**RE: Solar Photovoltaic Plants
2150 Dryden Road
Dryden-Tompkins Solar II, LLC
SWPPP Modification Report**

The Storm Water Pollution Prevention Plan for this project was submitted in June of 2017 and Revised May 2018.

FIGURE 1

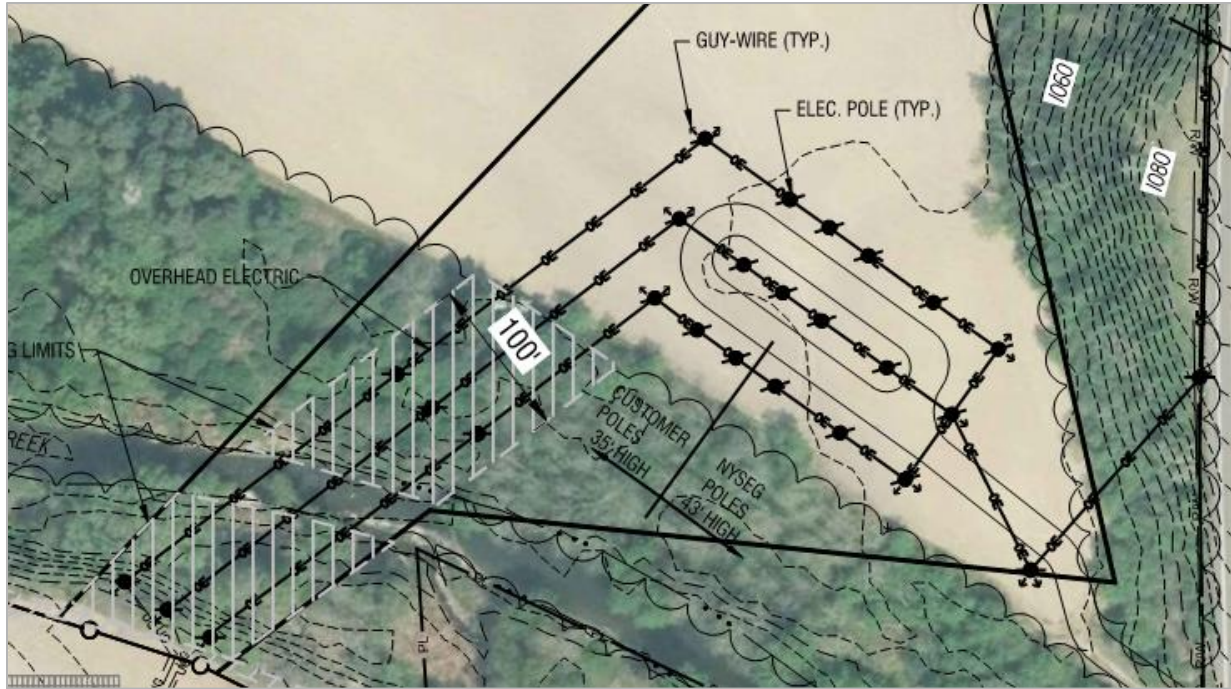
During the final electrical design of the project, three electrical lines were designed and it was determined that using overhead electrical lines over the creek would avoid any disturbance of the stream banks or bed. To provide NEC required clearances the poles lines must be a minimum of 30 feet apart and tree clearance must be at least 20 feet from the outside pole lines. (see figure 1) This results in a cleared width of 100 feet and a cleared area at the creek of 0.85 acres.

FIGURE 2

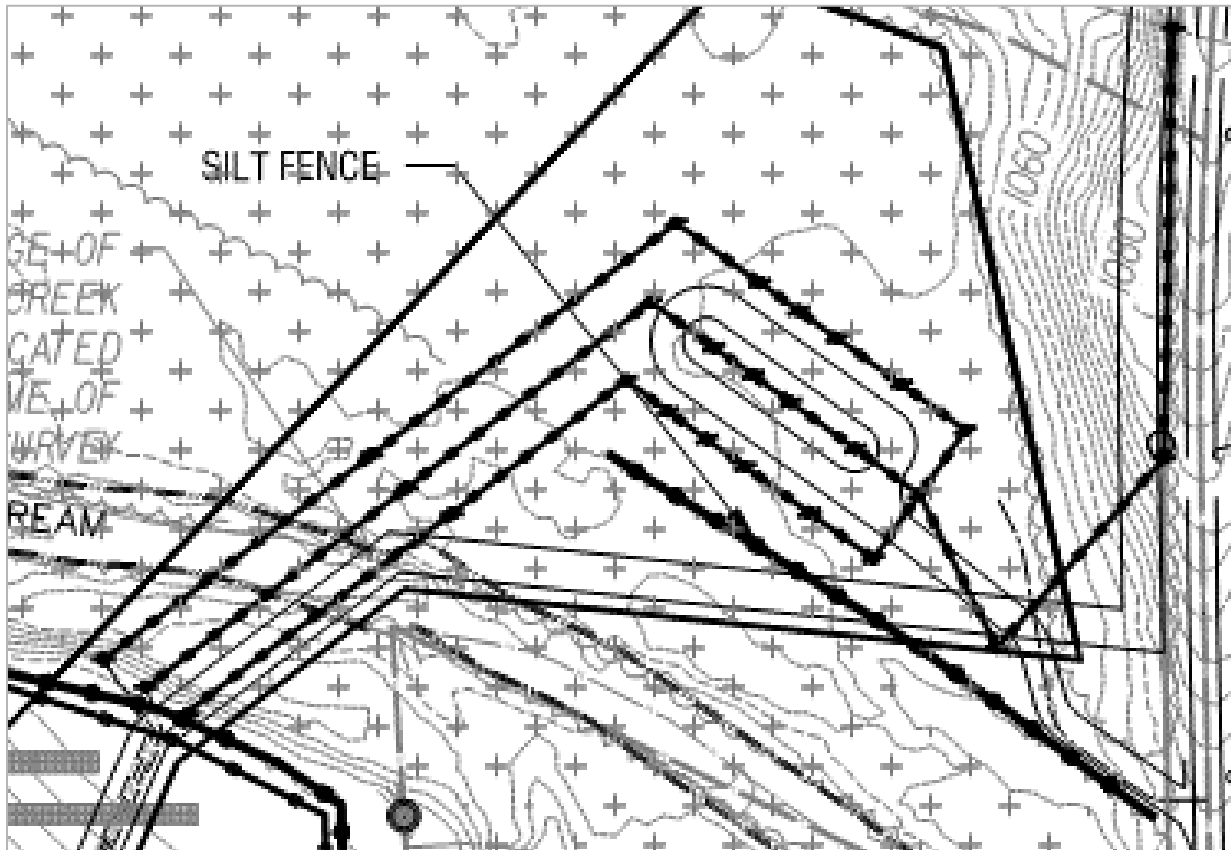
The Sediment and Erosion Control plan shows silt fence between the access road and the stream (see figure 2) and the existing meadow vegetation will be maintained between the pole line and the wooded streambank.
